Re: NCIRT Review and USACE Approval of the Cedar Branch Restoration Site Draft Mitigation Plan; SAW-2003-21395; DMS Project #97009

NCDMS Project Name: Cedar Branch Restoration Site, Randolph County, NC
USACE AID#: SAW-2003-21395
NCDMS #: 97009

SUBJECT: Cedar Branch Restoration Site - NCIRT Comments during 30-day Mitigation Plan Review

Subject: Cedar Branch Restoration Site
Draft Mitigation Plan – Credit Revisions
Lower Yadkin River Basin - 03040103
Randolph County, North Carolina
Contract No. #6598
DMS Project #97009

7.5 Proposed Mitigation Type

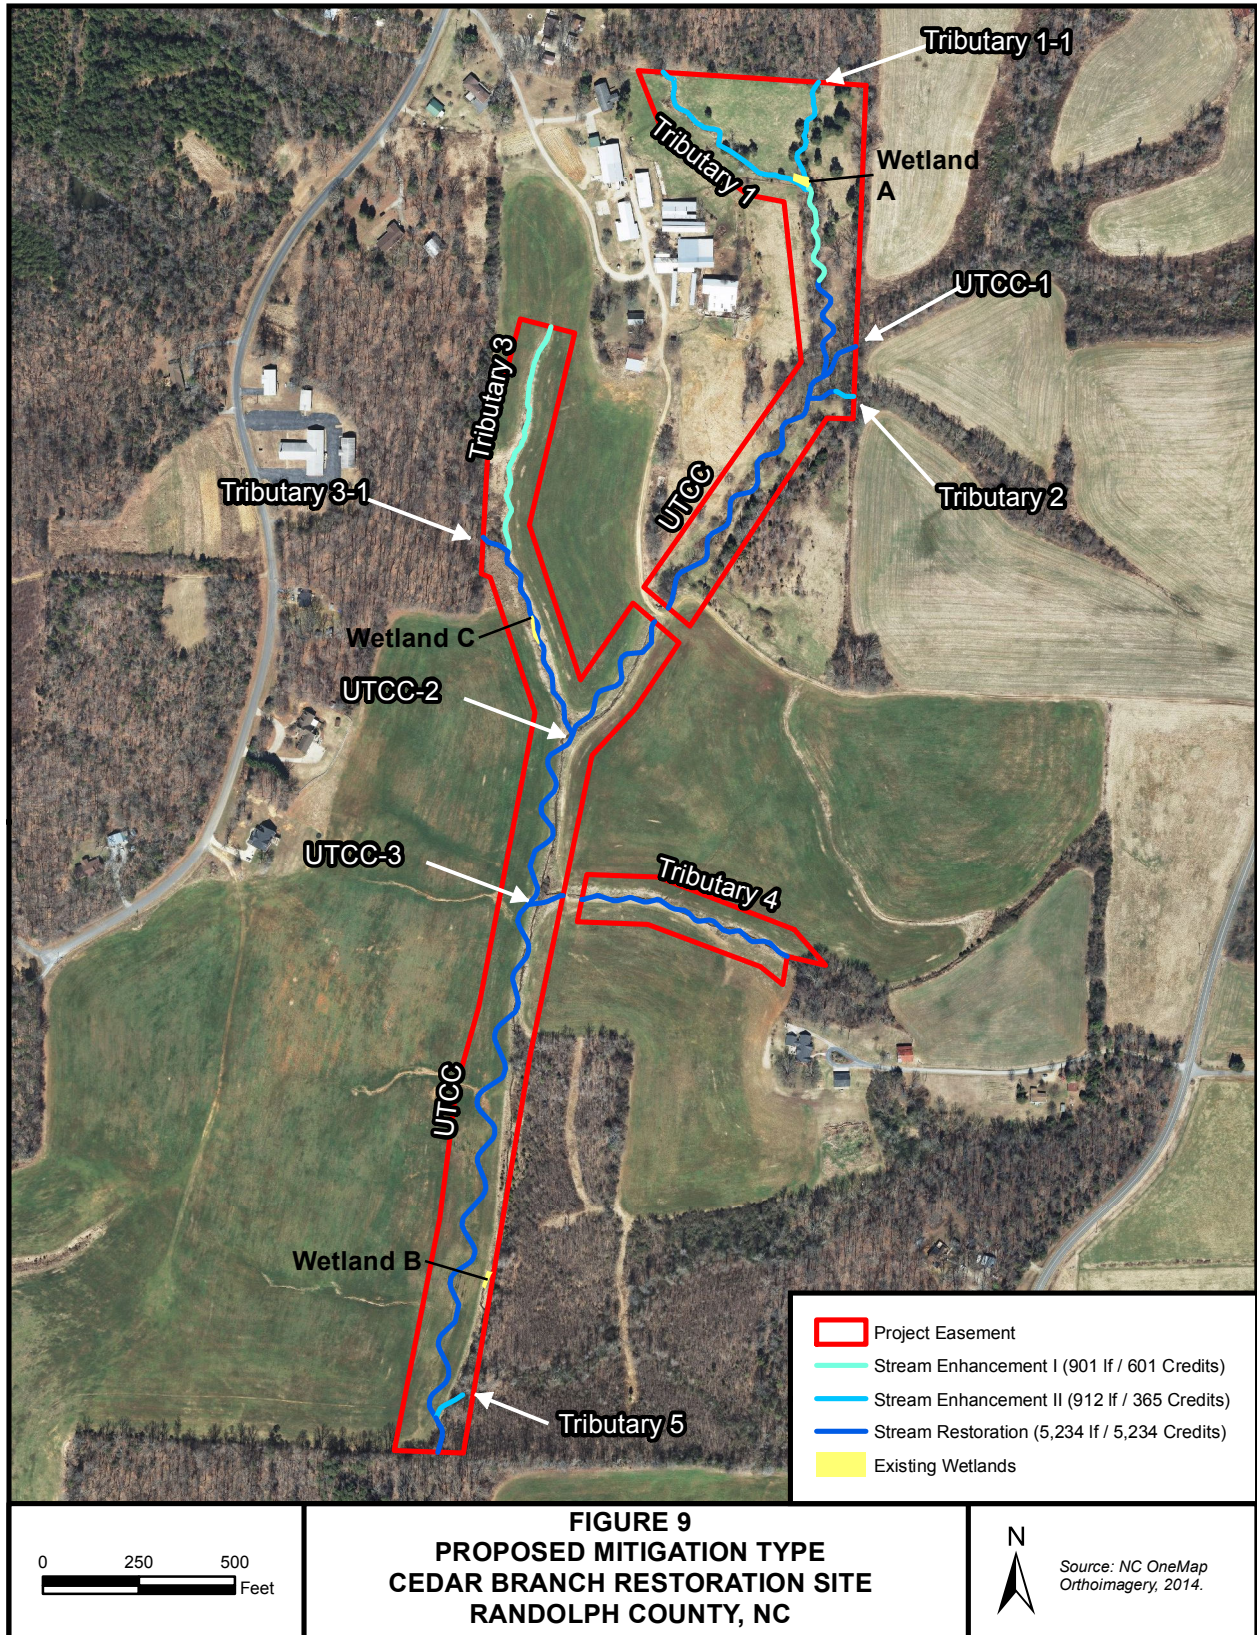
13. Appendix C: Regarding the monitoring plan, we recommend adding a cross-section below the proposed road crossing on UTCC. Also, regarding proposed treatments, the monitoring map is not consistent with Table 20 or the figures on pages 28 and 29.

We apologize for not having the monitoring map up-to-date; it has been updated. We have also added the additional cross-section on UTCC.

See previous response to DWR comments above. We will install pressure transducers on the intermittent reaches of T1, T1-1, and T3 as well as on the bottom of UTCC for bankfull monitoring. The approximate locations of these gauges have been marked on the revised monitoring map in Appendix C.

WATER QUALITY TREATMENT AREA
SCALE: NTS

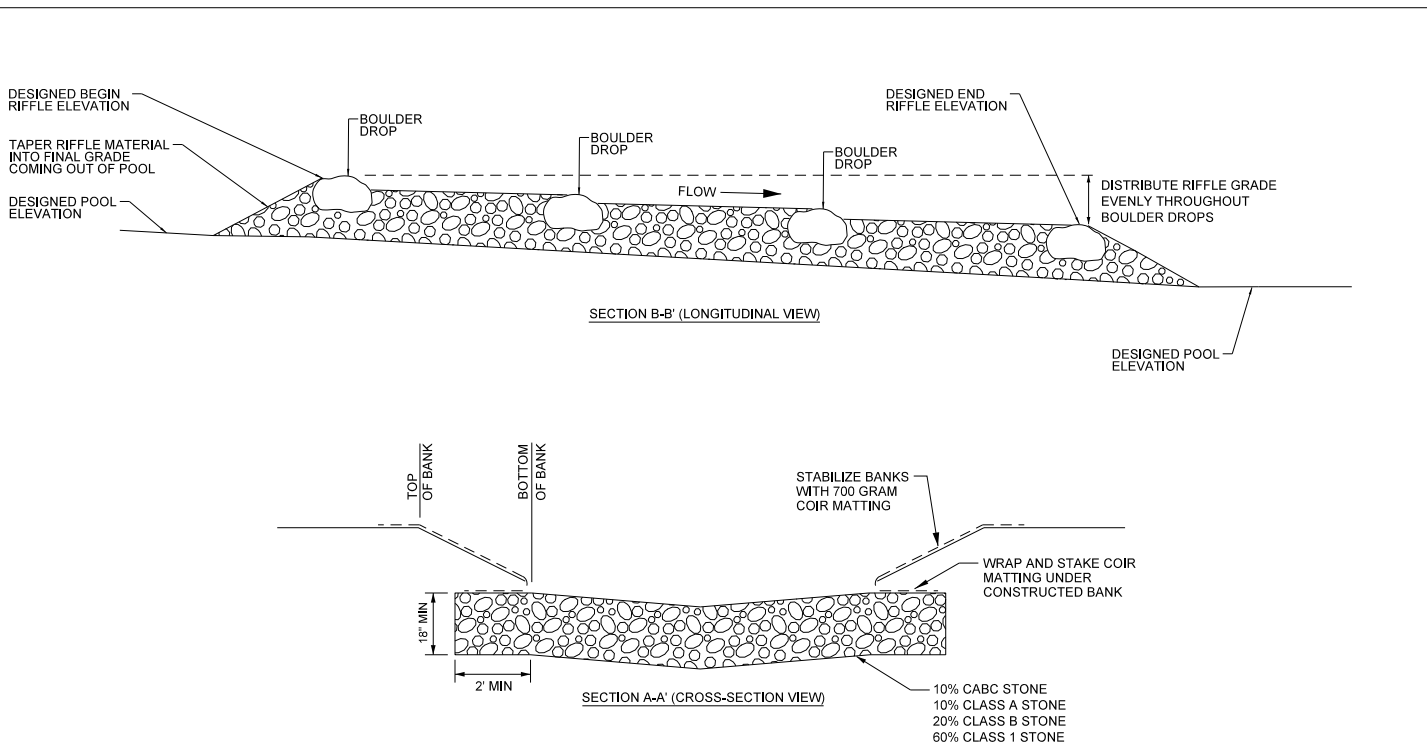
8. Although the stormwater BMP's are not proposed for mitigation credit, DWR is concerned that the proposed design may result in long term impacts to the receiving stream and/or buffers. Specifically, DWR has concerns that the plans indicate a shallow detention area of natural soils which appear to be un-vegetated which is to be covered by an installed mulch layer. Without ensuring sufficient infiltration rates of the soil below the detention area, the area is likely to pond regularly and the mulch is likely to redistribute and not provide proper soil coverage to ensure that erosion will not occur within the area. In addition, there is a concern that the mulch will be washed into the rock outlet when the area is completely ponded during heavy storm events.

6. Page 22, Section 7.2: The plan indicates two BMPs will be constructed within the boundaries of the mitigation site. The plan sheets indicate these areas will be graded to a depth of 6 inches and layered with mulch. We concur with DWR concerns regarding the placement of mulch and would prefer these areas be vegetated. While the provider is not requesting mitigation credit associated with the BMPs, these areas are located within buffer areas that would typically be planted with woody vegetation.

KCI has used similar structures on our past projects and has not experienced this problem. However, we will add a 2" layer of topsoil above the mulch and then the entire BMP will be seeded with a wetland mix and stabilized. These BMPs generally become vegetated quickly due to the high incoming nutrient loads. This vegetation stabilizes any disturbed soils and/or mulch in the structure. However, KCI will watch these structures post-construction to ensure that no erosion is occurring. They have been added explicitly to our "Planned Maintenance" table in the mitigation plan.

Please see previous response to DWR. We are not planning on planting these areas with woody vegetation since they are treating incoming agricultural run-off and herbaceous vegetation is more effective at providing treatment. These BMPs will be watched closely and included in our maintenance plan.
